# Access Compliance Report

## Public Rights-of-Way

Intersection ID: 10772	Main Street: E_36TH_ST	Cross Street: THE_PLAZA	Location: N
ADA ID: 030E7B0F69D5	Ramp Type: PerpDiag	Initial Pass/Fail: Fail	Overall Compliance: No
Severity Score: 8.75			
Codes/Mitigation Info/Possible Solution		Field Measurements/Component Compliance

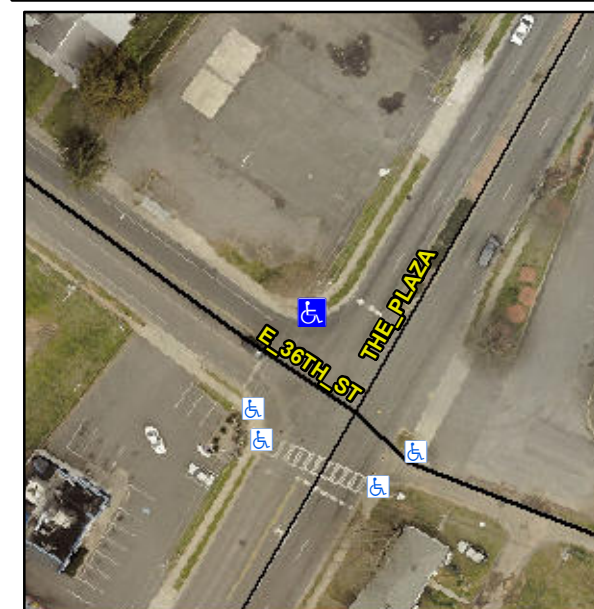
**Not Found, R304.5.1**

Compliance	Description	Data	Compliance	Description	Data
N/A	Ramp Length (in)	47.0	Yes	Ramp Slope (%)	8.1
No	Ramp Width (in)	41.5	Yes	Ramp XSlope (%)	1.7
N/A	Flare Type LT	N/A	N/A	Flare Type RT	N/A
N/A	Flare Slope LT (%)	N/A	N/A	Flare Slope RT (%)	N/A
N/A	Flare Traversable LT?	N/A	N/A	Flare Traversable RT?	N/A
N/A	Landing Length (in)	N/A	N/A	DWS Provided?	N/A
N/A	Landing Width (in)	N/A	N/A	DWS Contrast?	N/A
N/A	Landing Slope (%)	N/A	N/A	DWS Length (in)	N/A
N/A	Landing X Slope (%)	N/A	N/A	DWS Full Width?	N/A
N/A	Landing Curb? (Y/N)	N/A	N/A	DWS Offset (in)	N/A
N/A	Shared Landing?	N/A			
N/A	Gutter Ponding?	N/A	N/A	Gutter Slope (%)	N/A
N/A	Gutter Lip Ht (in)	0.5	N/A	Gutter X Slope (%)	N/A
N/A	Painted X Walk1?	Yes	N/A	Painted X Walk2?	No
	X Walk 1 Direction	To SW		X Walk 2 Direction	To SE
N/A	X Walk 1 Width (in)	107.0	N/A	X Walk 2 Width (in)	N/A
	X Walk 1 Slope (%)	0.0		X Walk 2 Slope (%)	4.1
	X Walk 1 X Slope (%)	1.1		X Walk 2 X Slope (%)	1.2

**Remove & Replace Curb Ramp With Two New Directional Ramps or Equivalent.**
